# ADDENDUM NO. 3

**August 13, 2026**

Perry Township Schools:
Southport High School Addition & Renovation Phase 2 (Classroom Addition and Athletic Renovations)
971 E. Banta Road
Indianapolis, IN 46227

# ROOF FRAMING PLAN - UNIT P

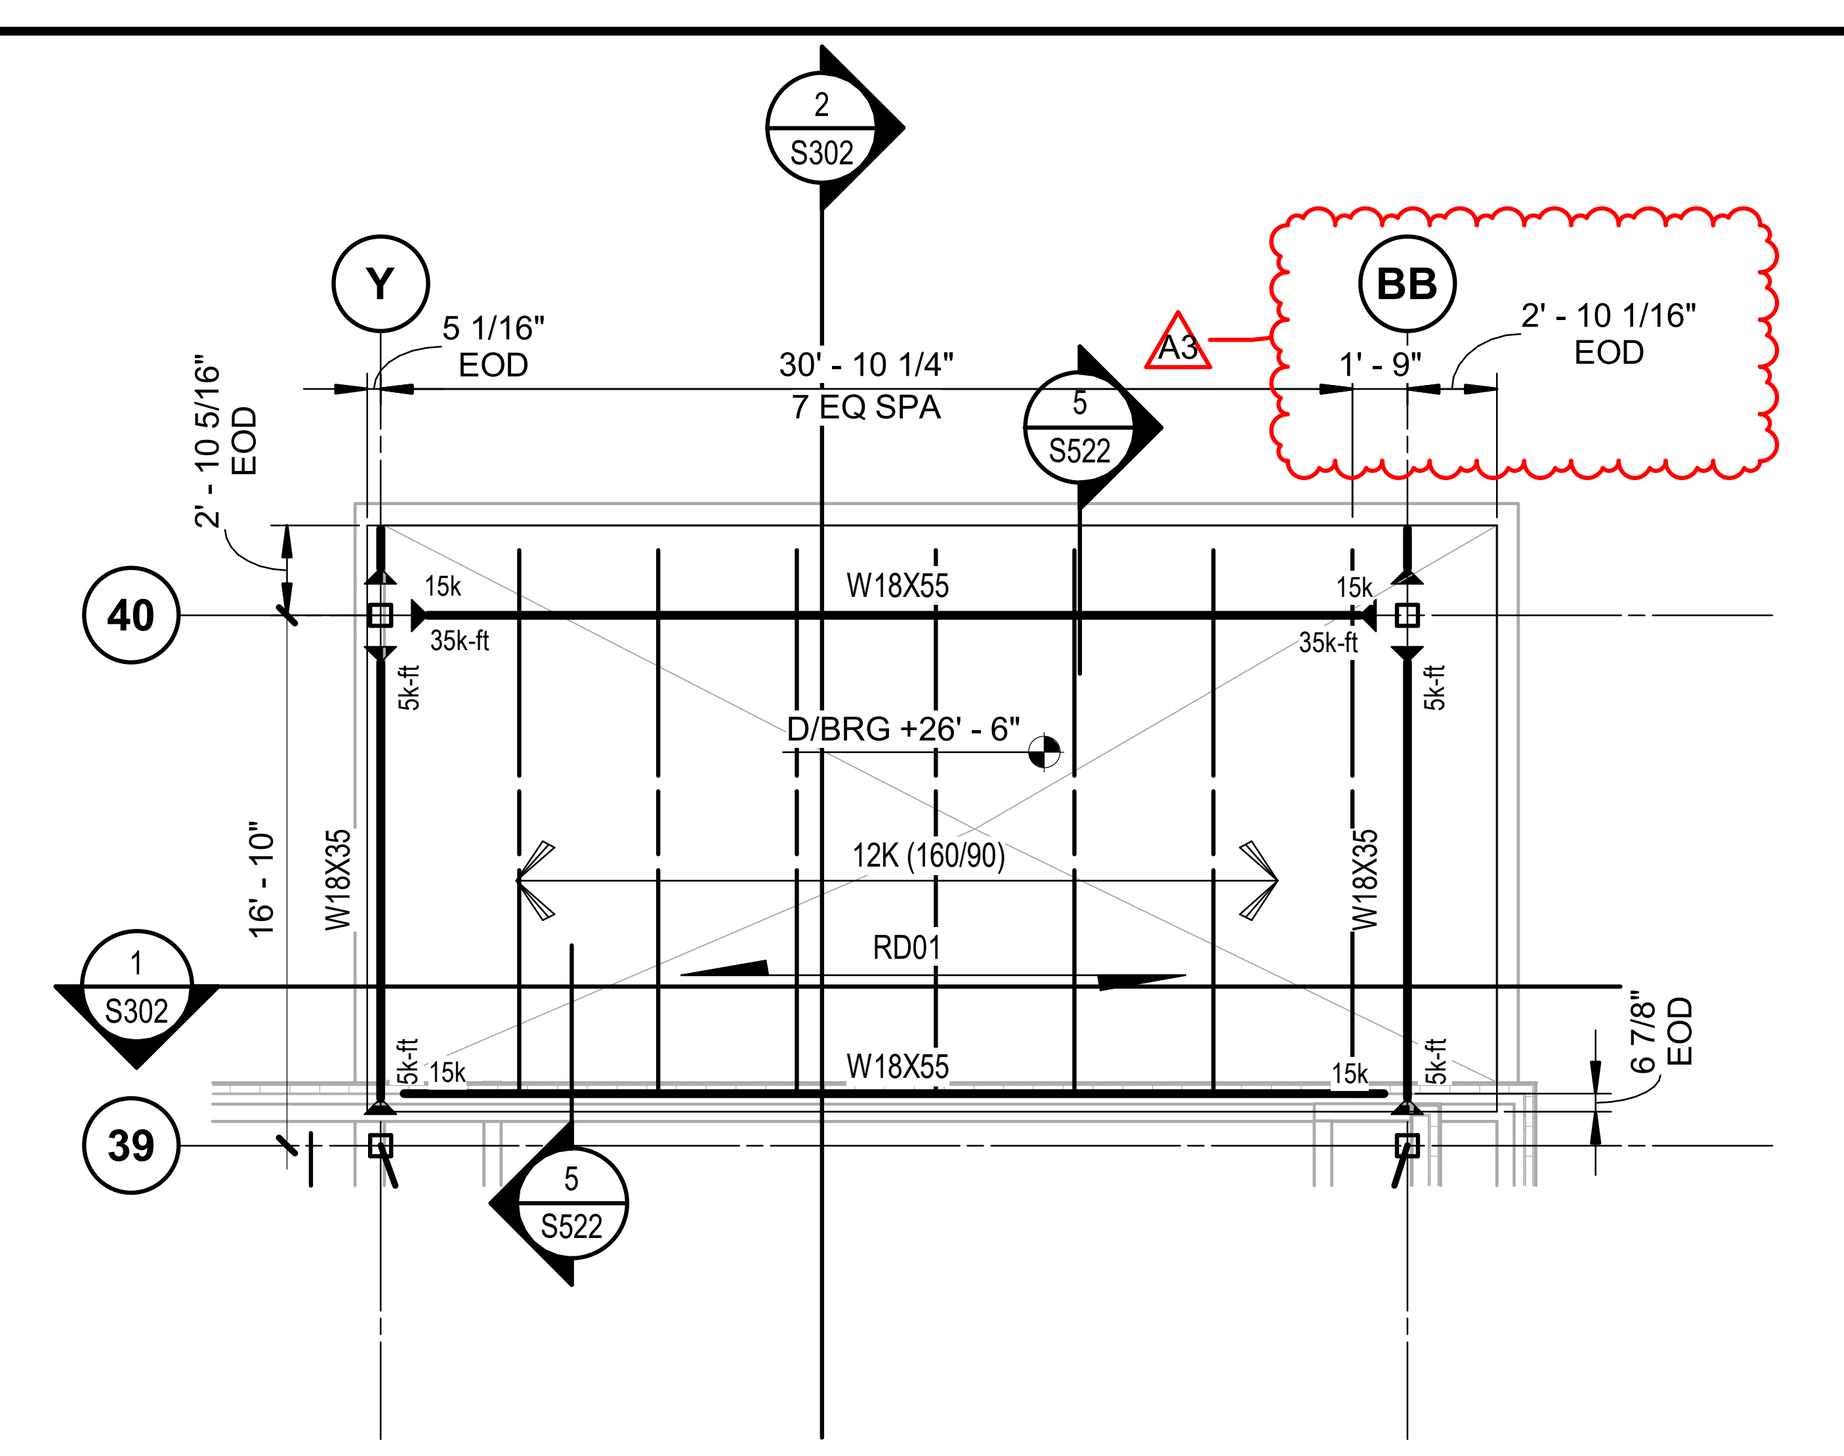
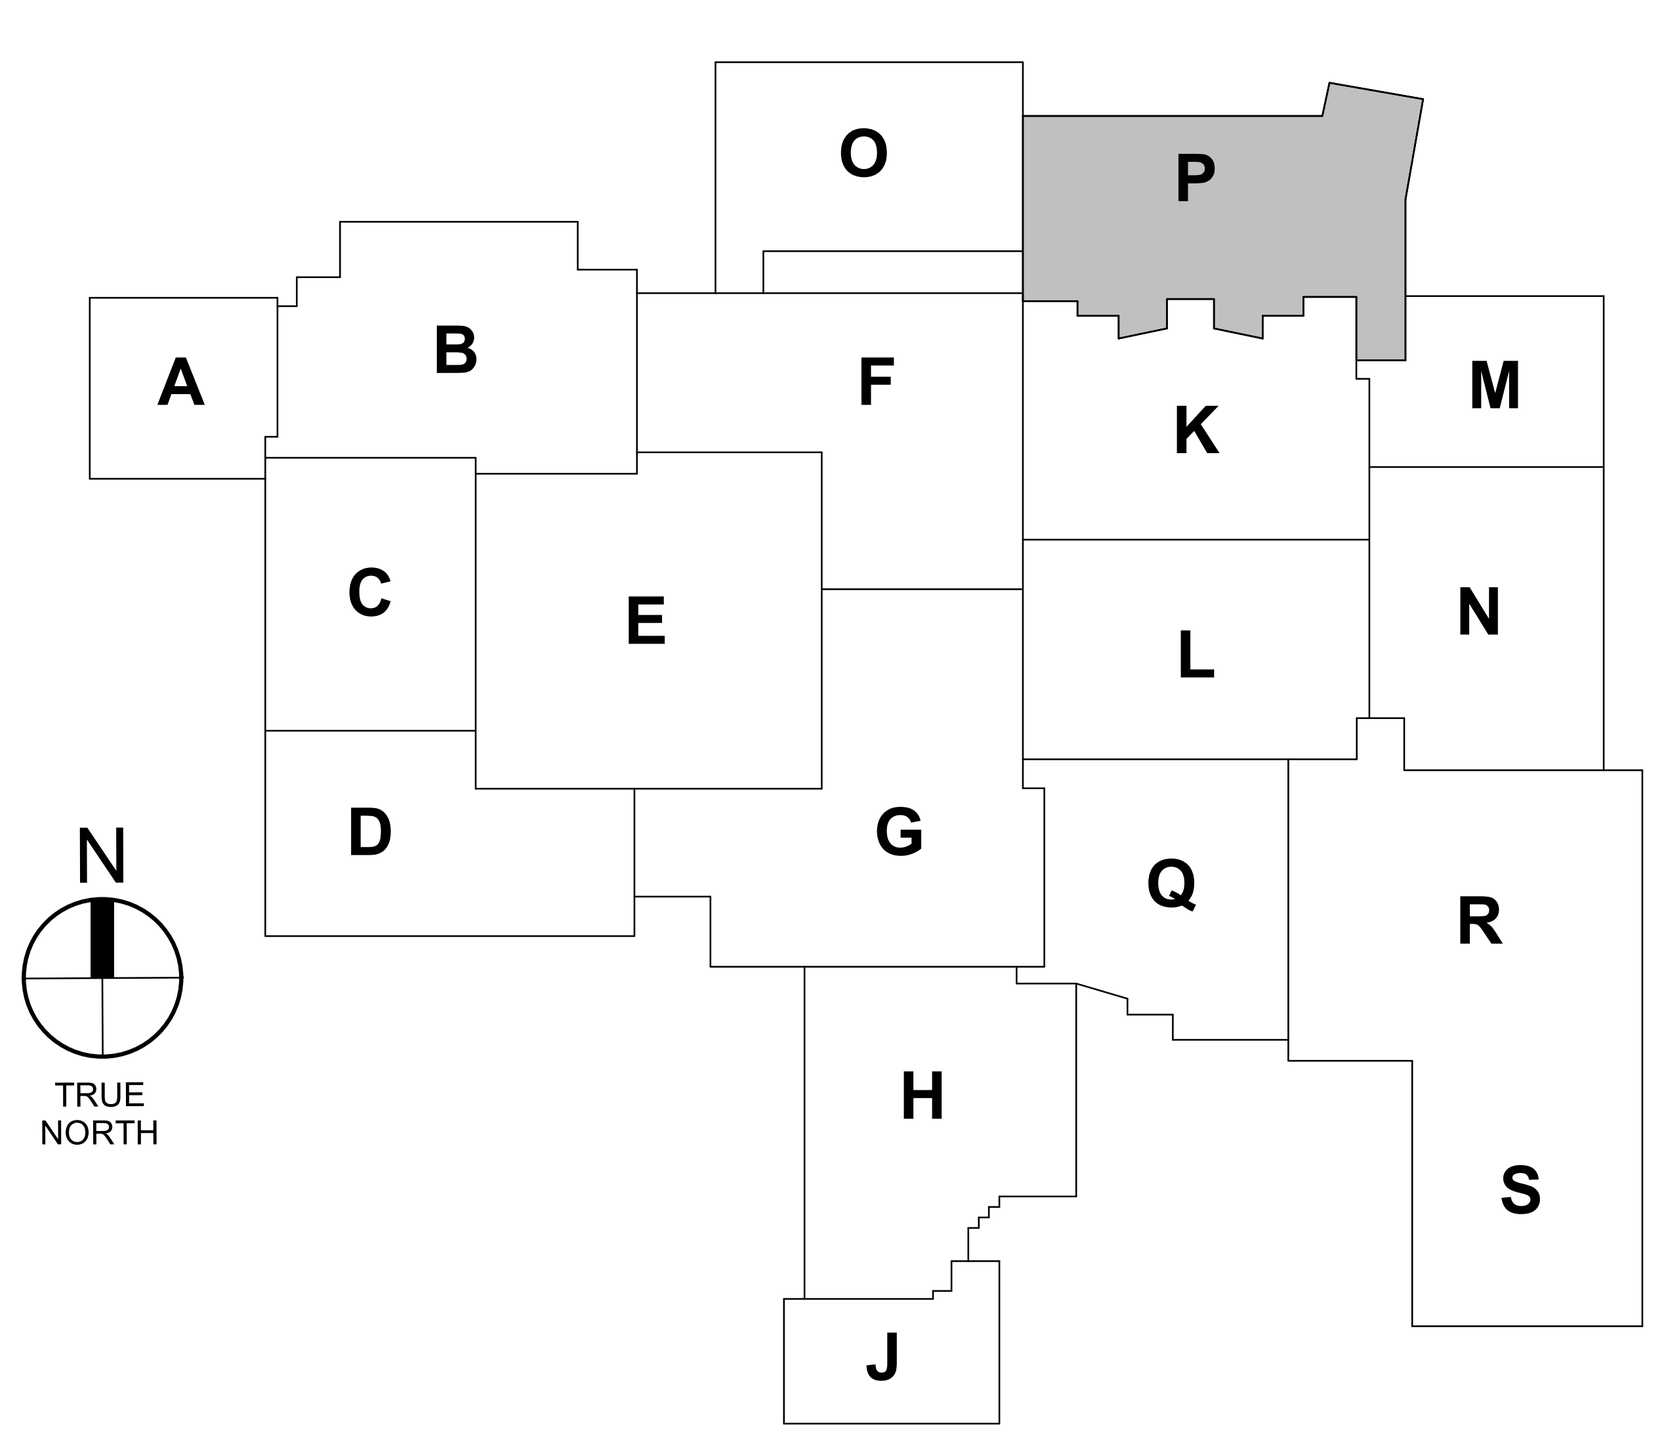
Change: Plan
    - Geometry updates for new RTU types.
    - Grid BB shifted plan West 3” – see ROOF FRAMING PLAN – UNIT P and LOW ROOF ENLARGED PLAN

## 2 NORTH VESTIBULE BUILDING SECTION

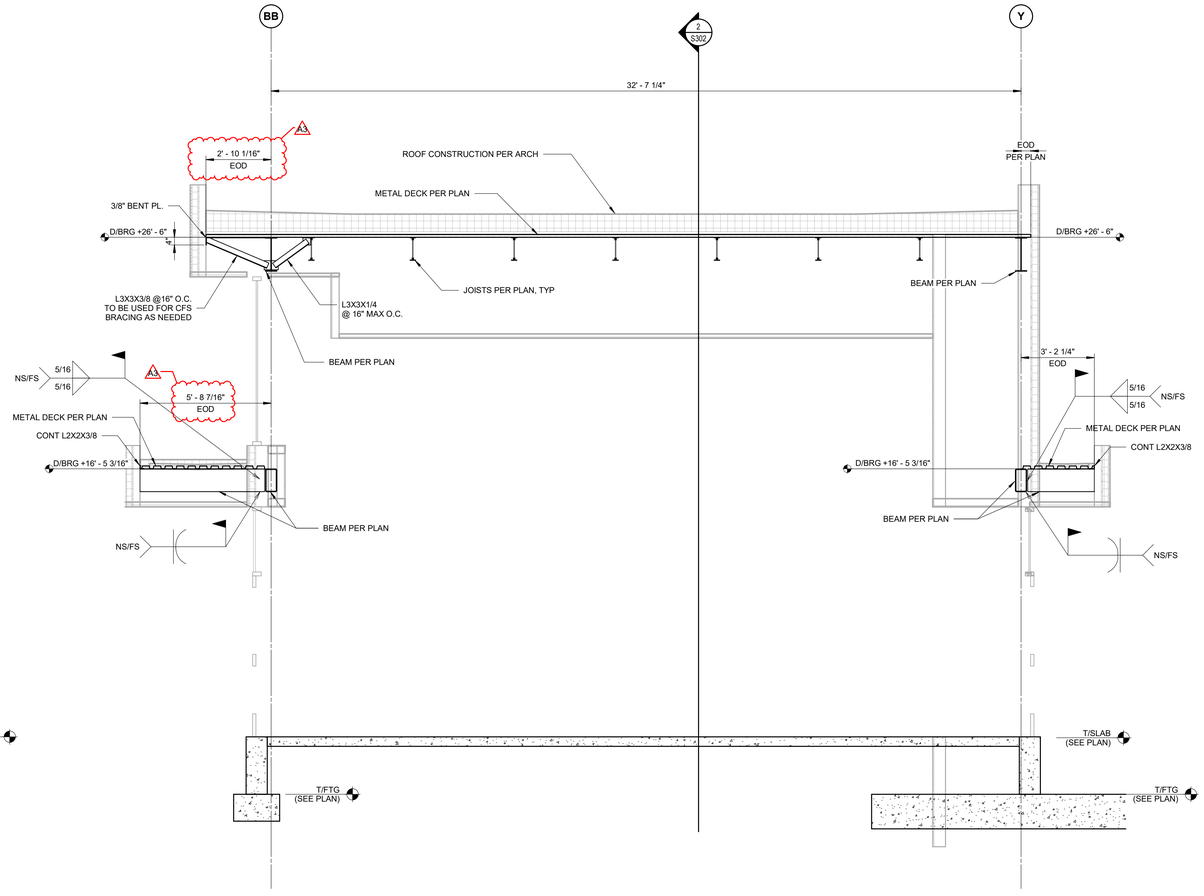
Change: Plan
- EOD dimensions updated for grid BB shift

S500

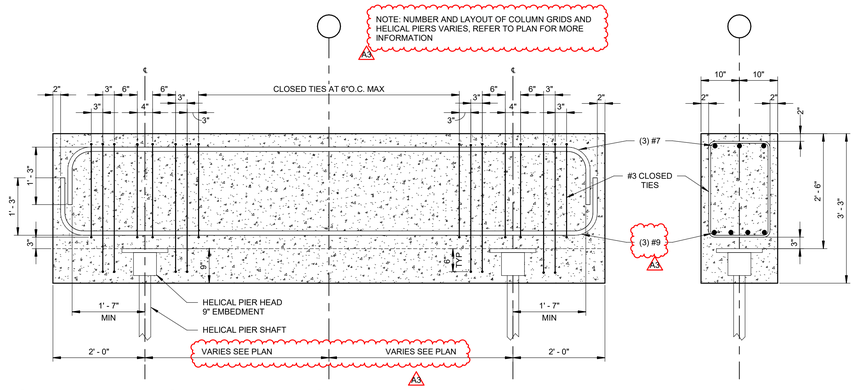
Change: Plan
- Pier Schedule updated with new pier type P6
- Detail 6/S500 pier plan added for reinforcement clarification

3 S504 **GRADE BEAM GB3 DETAILING**

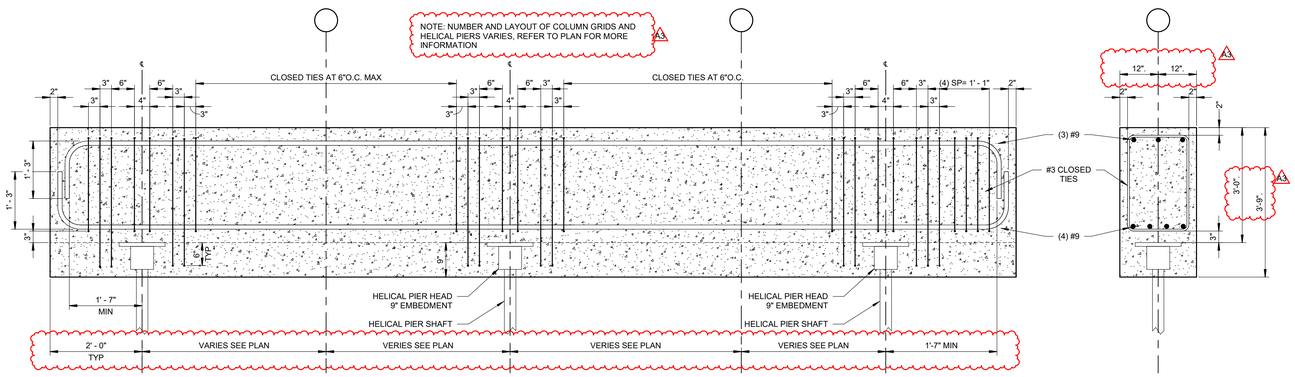
1. Q: Please provide a schedule for the Grade Beams.
   A: See sheets S504 within this addendum.

Change: Elevations
- Adjusted dimension annotations to be coordinated with the plan.
- Added note regarding field verification.
- Adjusted reinforcing.

## 2 ROOF PLAN - ENTRY CANOPY ROOF.

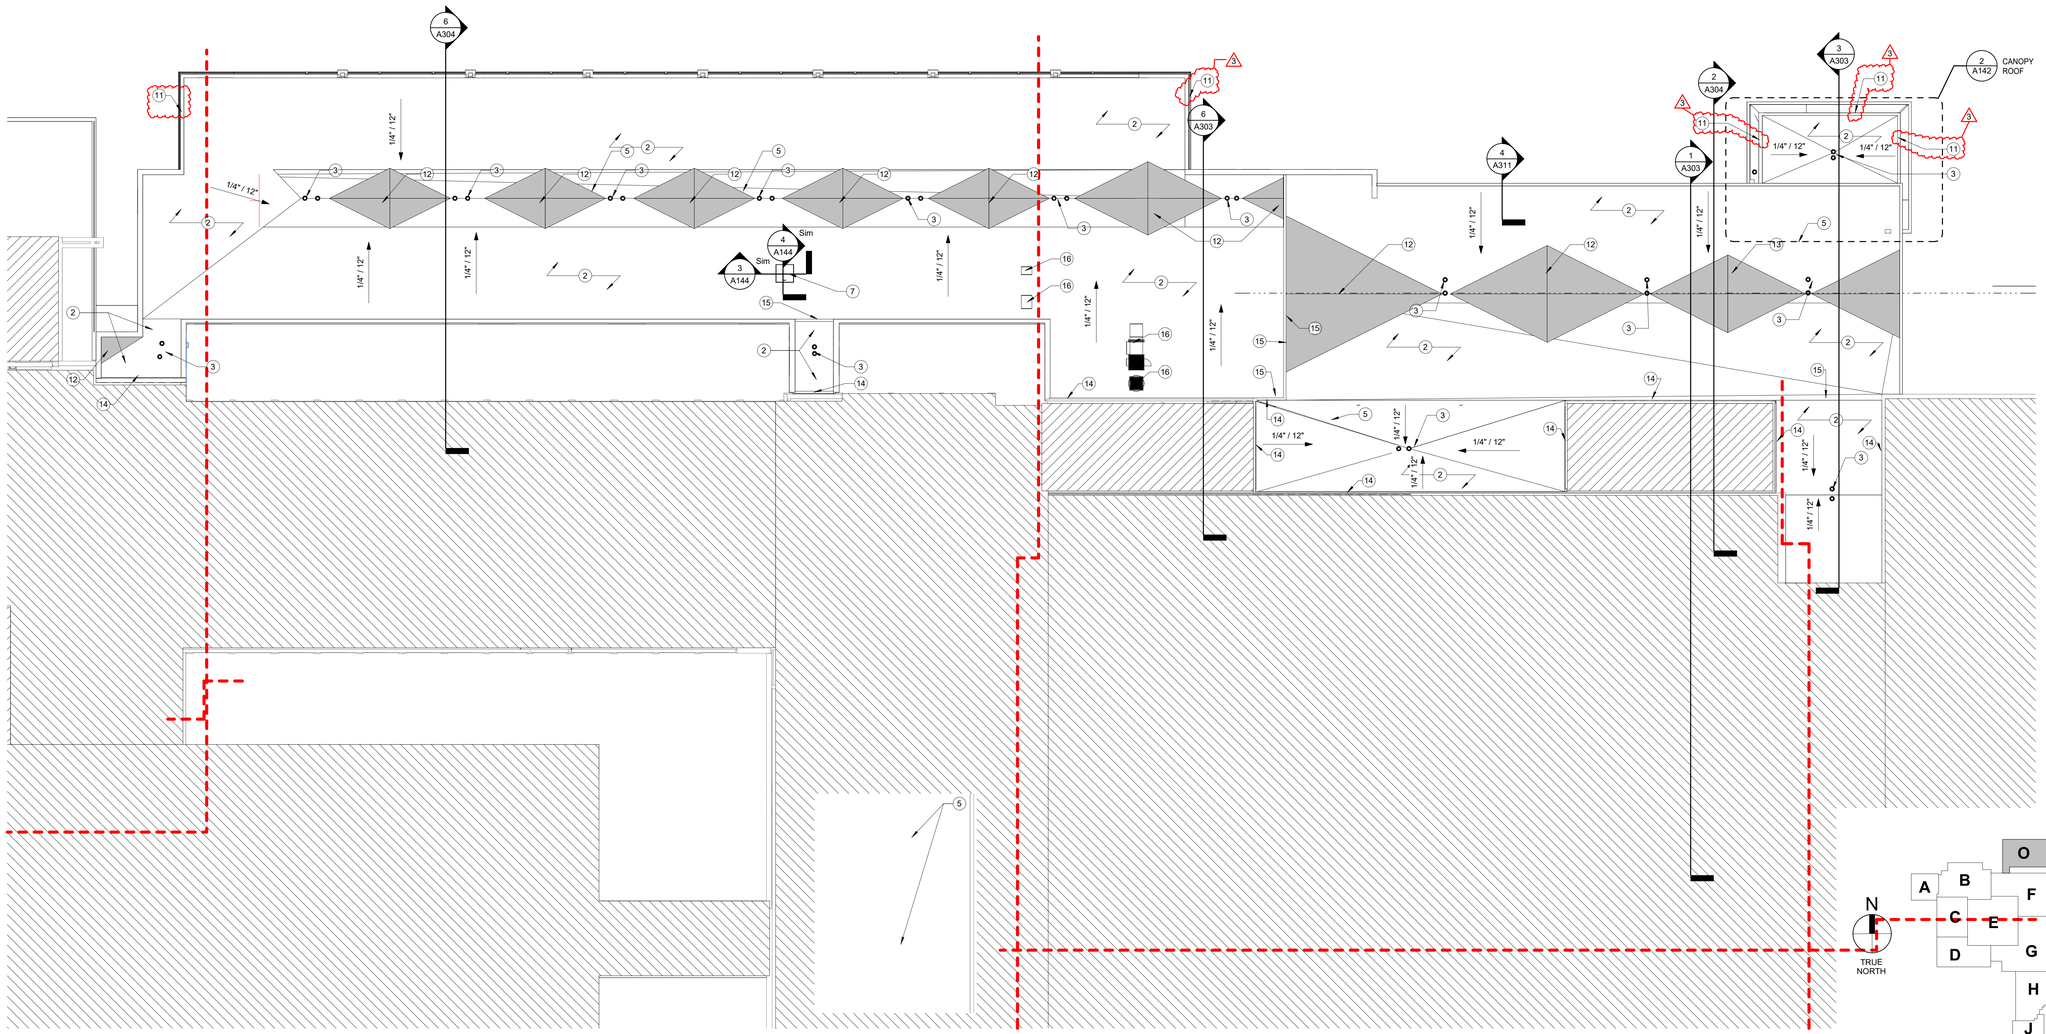
Change:
    - Adjustment placement of plans on sheet
    - Change keynote references at keynotes 11 and 15.
    - Add keynote 11 to the roof plan.
    - Enlarged scale of view #2 and added notation and dimensions.

4 BldgSection Ph02_17
SCALE: 1/8" = 1'-0" REF. 1 / A101P

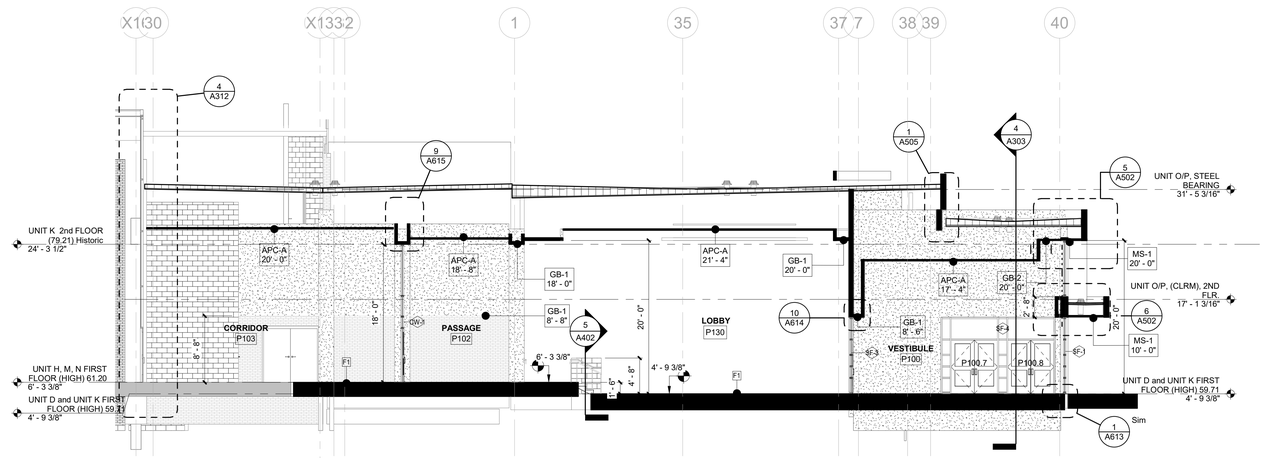
Change:
    - Added callout to view #4.
